SEWAGE DISPOSAL SYSTEM

HOWARD COUNTY
BUREAU OF ENVIRONMENTAL HEALTH
992-2330

SUBDIVISION _____ ROAD 2460 Mullinix Mill LOT _____

PLOT PLAN
 SCALE 1" = 100'

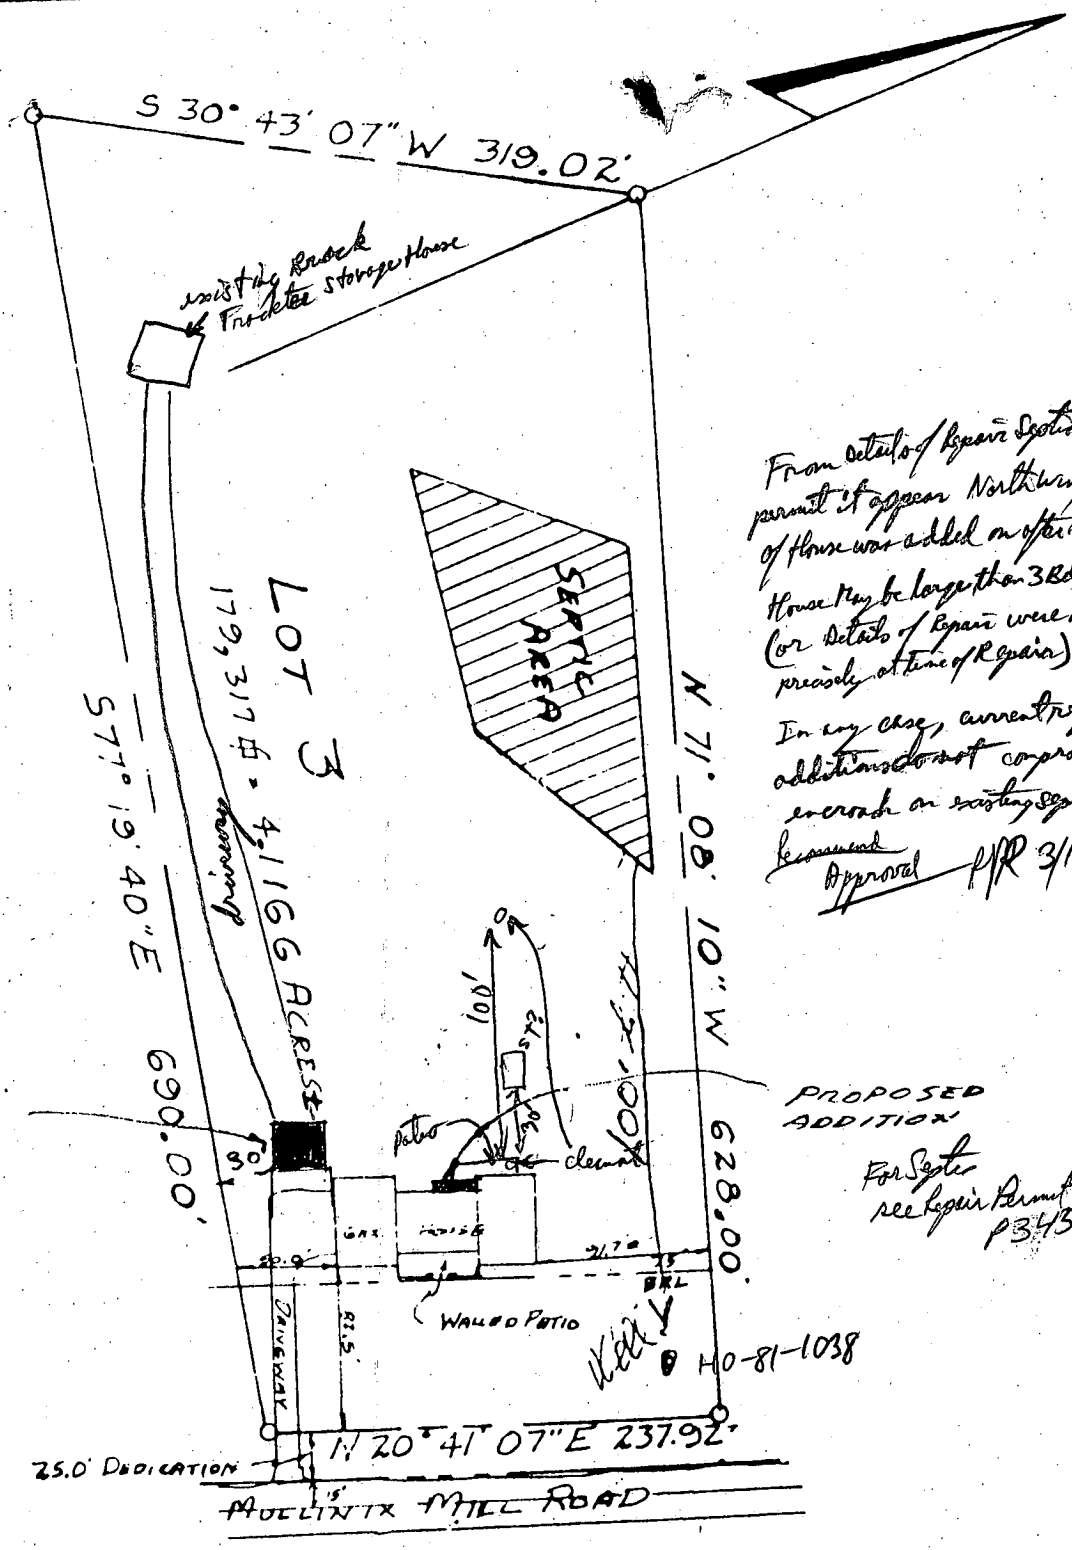
From details of Repair System
 permit it appear North wing
 of house was added on after last Repair
 House may be larger than 3 Bds original,
 (or details of Repair were not oriented
 precisely at time of Repair)
 In any case, current request for
 addition does not compromise or
 encroach on existing Septic or Repair area
 Approved P/R 3/17/94
